| Office Action Summary | Application No. 10/812,959 | Applicant(s) KOMATSUBARA, HIROTAKA | |

DETAILED ACTION

Fig. 10

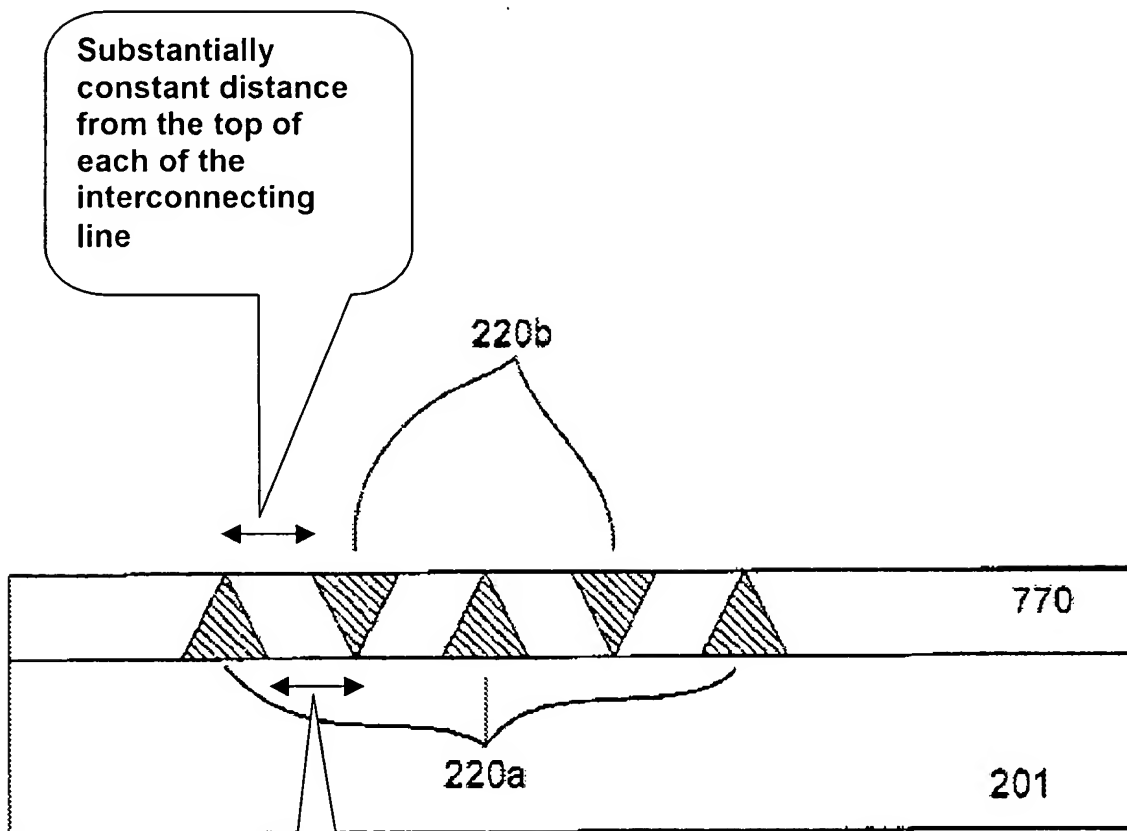
6. Claim 1 is rejected under 35 U.S.C. 102(b) as being anticipated by Park et al. (U.S. Pat. 6,469,392).

Park (Fig. 10) discloses a semiconductor device having a plurality of interconnecting lines (220a, 220b) (column 2, lines 1-6) disposed side by side in a dielectric film 770, each interconnecting line having a top, a bottom, and a width (column 1, lines 65-67 and column 2, lines 1-4), wherein:

the width of each interconnecting line 220 varies from the top of the interconnecting line to the bottom of the interconnecting line 220; and

each mutually adjacent pair of the interconnecting lines (220a, 220b) is separated by a substantially constant distance from the top of each of the interconnecting lines (220a, 220b) in the mutually adjacent pair to the bottom of each of the interconnecting lines (220a, 220b) in the mutually adjacent pair (See Fig. 10 labeled by the examiner below).

FIG. 2A OF MATSUKAWA

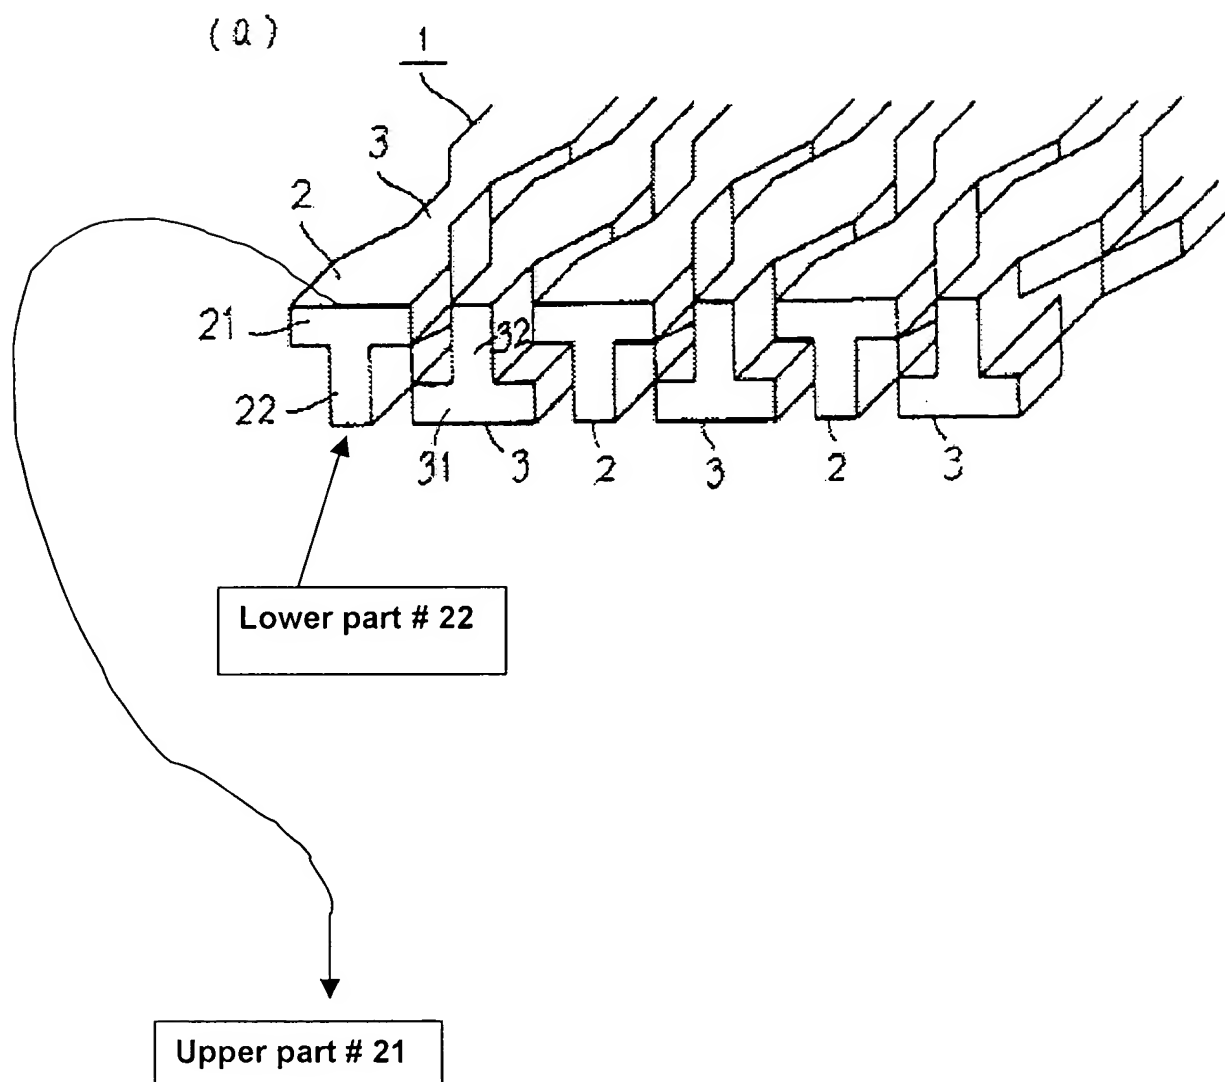
However, Matsukawa (Fig. 2a) teaches a semiconductor device including a plurality of interconnecting lines (2,3) having cross-sectional T shapes, the interconnecting lines 2 having upright cross-section T shapes are disposed alternately with interconnecting lines 3 having inverted cross-sectional T shapes in order to obtain the T shaped interconnecting lines which has high wiring density and which can

Regarding claims 4-5, Matsukawa (Fig. 2a) further discloses that each cross-sectional T shaped interconnecting line 2 (or 3) has an upper part 21 having a first constant width and a lower part 22 having a second constant width, the second constant width differing from the first constant width (see Fig. 2a labeled by the examiner below) (claim 4); and the interconnecting lines 2 in which the upper part 21 is wider than the lower part 22 are disposed alternately with interconnecting lines 3 in which the lower part 31 is wider than the upper part 32 (see Fig. 2a labeled by the examiner below) (claim 5).

Regarding claims 6-7, as discussed above, Matsukawa's Fig. 2a teaches the forming of the upright T shaped interconnecting lines 2 disposed alternately with the inverted T shaped interconnecting lines 3 in order to obtain the T shaped interconnecting line structure which has high wiring density and which can enhance the positioning margins between the wirings and the layers in a multilayer wiring structure (See abstract).

Matsukawa does not disclose that each of the T shaped interconnecting lines (2,3) having the upper part and the lower part equal in heights and equal to one-half of a height of the interconnecting lines.

However, it is noted that the Federal Circuit held that where the only different between the prior art and the claims was a recitation of relative dimensions of the claimed device and a device having the claimed relative dimensions would not perform differently than the prior art device, the claimed device was not patentably distinct from the prior art device. ***In Gardner v. TEC Systems, Inc., 725 F.2d 1338, 220 USPQ 777 (Fed. Cir. 1984), Cert. Denied, 469 U.S. 830, 225 USPQ 232 (1984).*** Therefore, it would have been obvious to one having ordinary skill in the art at the time of the invention was made to modify the T shaped interconnecting lines of Matsukawa by forming the upper part and the lower part equal in heights and equal to one-half of the interconnecting lines height because the changes in heights of the upper part and the lower part of the T shaped interconnecting lines would provide the same results of increasing wiring density and enhancing the positioning margins between the wirings and the layers in a multilayer wiring structure.
